## ISAC Answers to Questions on Target Flows (from ISAC/TAC meeting on July 11, 2012 in Kearney NE)

## ISAC - Oct 9, 2012 discussion of Target Flows Process (Omaha): rationale and timeline, expectations management, steps and outputs

Figure 2. Reproduction of Figure 4-17 from NRC 2005. (Emphasis added to demonstrate portion of IFIM used)

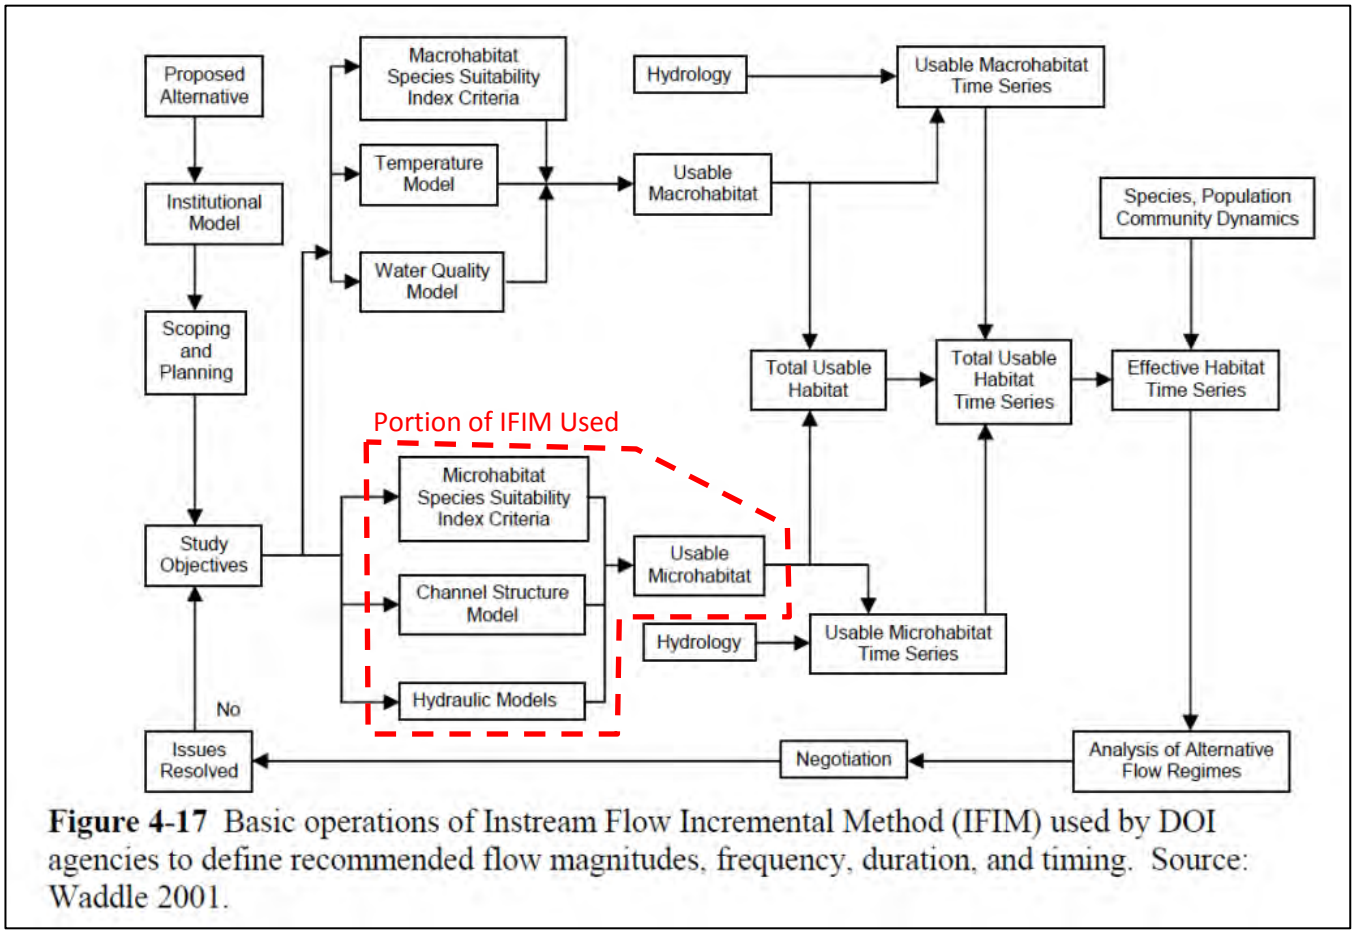
In fact, the role that IFIM played in development of the target flows is much more limited than understood by the NRC and implied in other documents. Specifically, the Physical HABitat SIMulation System (PHABSIM), which is one of the modeling tools associated with IFIM, was used to quantify the amount of microhabitat for fish and whooping cranes at different flow levels. This portion of the IFIM is identified in Figure 2, which is a reproduction of NRC Report Figure 4-17 (note the implication in the figure's descriptive legend that the IFIM process was used by DOI agencies to establish all aspects of the target flows). The Service (assisted by other agencies and cooperators) compiled the microhabitat data into Habitat Availability (HA) curves for forage fish and whooping cranes. Crane and fish-related flow targets are based on optimization of HA from those curves. None of the components of the IFIM were used for establishment of pulse or peak target flows. As shown in the emphasized area of Figure 4-17, the IFIM process was not used in whole, and would have required integration of macrohabitat data, historic hydrology, analysis of alternative flow regimes and negotiation to establish flow targets that account for benefits and tradeoffs of competing water uses.

Figure 4. Reproduction of Figure B3 from USFWS 1994.

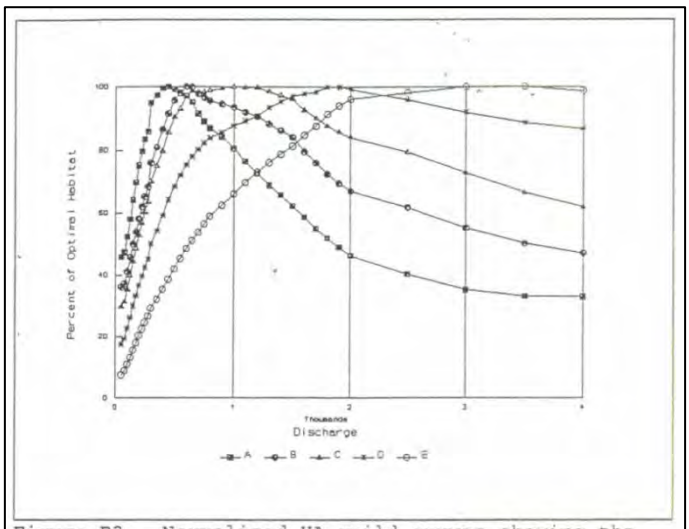
Second, the averaged HA curve indicates very little difference in percent of optimal habitat area across a range of flows. USFWS 1994 did not include a figure of the averaged HA curve so the EDO recreated it (Figure 5) from the guild HA data in DOI 2005. The averaged curve indicates that there is only a 1.9% change in the percent of optimal habitat for the range of discharges from 600 cfs to 1,200 cfs. However, over

Figure 5: Averaged HA curve showing the percent of optimal habitat as a function of discharge for all guilds.

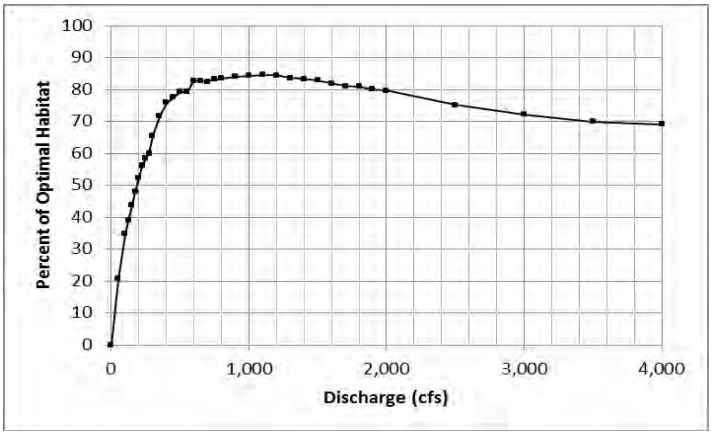
the course of a year, the difference in flow volume is 434,380 acre-ft. Incremental benefit/tradeoff issues like this are one of the reasons that IFIM guidance documents recommend against standard-setting based solely on PHABSIM model output.

Figure 6. Reproduction of Figure B3 from USFWS 1994 with emphasis added to show Kingsley BO HA curve.

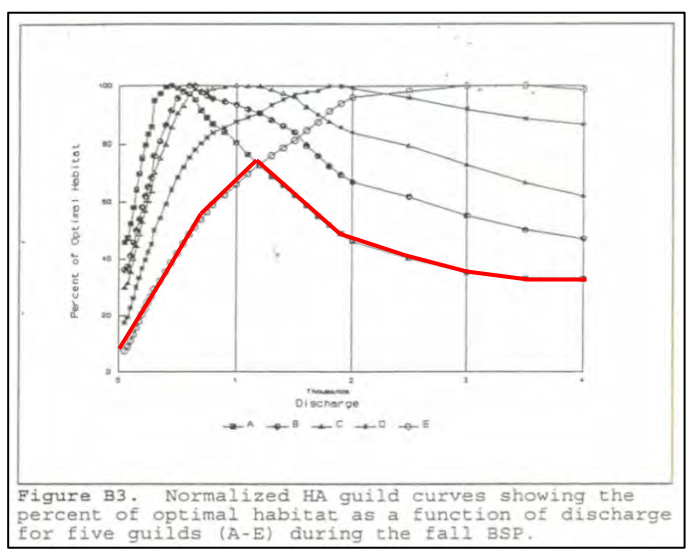
The PHABSIM analysis was subsequently updated by the Service for the 1997 Kingsley Dam Biological Opinion (USFWS 1997). The updated analysis produced a slightly higher flow target of 1,200 cfs. This is due to the use of a different optimization technique. Instead of identifying the highest average (or optimized) value for all guild HA curves, the Service chose to minimize the negative impacts to any single guild by drawing a "composite" suitability curve that corresponded to the lowest percent of optimal habitat among all guilds across the range of modeled discharges.

Because of this, the BO analysis is driven entirely by Guilds A and E. Up to 1,200 cfs, the relationship is based on the HA curve for Guild E and above 1,200 cfs it is based on the curve for Guild A (see Figure 6). Leonard and Orth (1998) was cited as the source of this optimization method in Appendix J of the Kingsley BO. Upon examination, Leonard and Orth (1988) did not include any discussion of the method other than to apply it for the purpose of demonstrating the sensitivity of flow recommendations to the target species (or guilds) used in the analysis. That document includes the following statement: "When target species are being selected, consideration should be given to the profound effect that the selections may have on the resulting flow recommendation. It is possible to "stack the deck," either intentionally or accidentally, in favor of a specific flow recommendation." This sensitivity is apparent in Figure 6. If Guild E (channel catfish and gizzard shad) are removed from the analysis, the optimized flow would drop by approximately 400 cfs. If Guild D is also removed (common carp and chub species) from the analysis, the optimized flow would be on the order of 600 cfs.

The original source of the above referenced optimization method is Bovee 1982 with the Service using a simplified version of the author's matrix-based optimization method. Bovee 1982 called for a monthly analysis constrained by historic hydrology and recommended weighting species and life stage HA curves to reflect spatial requirements. If this optimization approach is used in the future, application of the full method should be considered.

Figure 10. Duncan gage discharge percentile analysis.

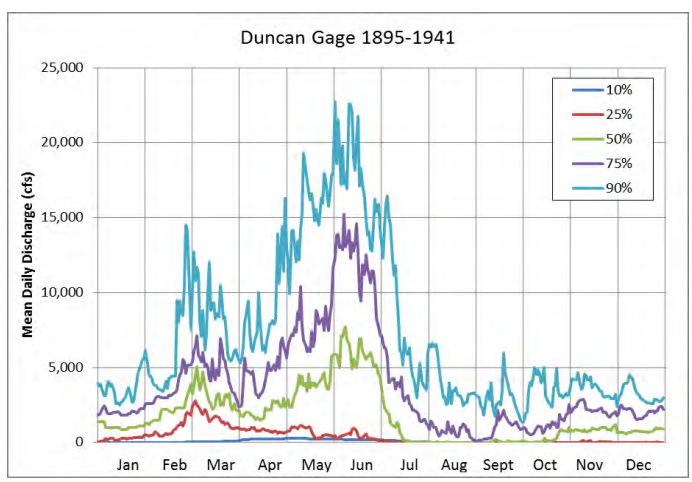
As mentioned previously, during the March 1994 workshop the Service identified and prioritized two pulse/peak flow periods of February - March and May – June. Although not explicitly stated, two flow periods were likely identified in order to mimic the natural hydrograph of the central Platte River. See Figure 10 for an EDO percentile analysis of discharge records for the Duncan gage

(USGS 06774000) from 1895-1941, which shows evidence of two runoff periods. The early runoff period was likely driven by local snowmelt and a late runoff period driven by snowmelt in the mountainous headwaters of the river. Analysis of Overton gage (USGS 06768000) records prior to the construction of Kingsley Dam (1930-1941) does not show two clearly defined runoff periods. However, the period of record is much shorter at 11 years and occurs during the drought years of the 1930s.
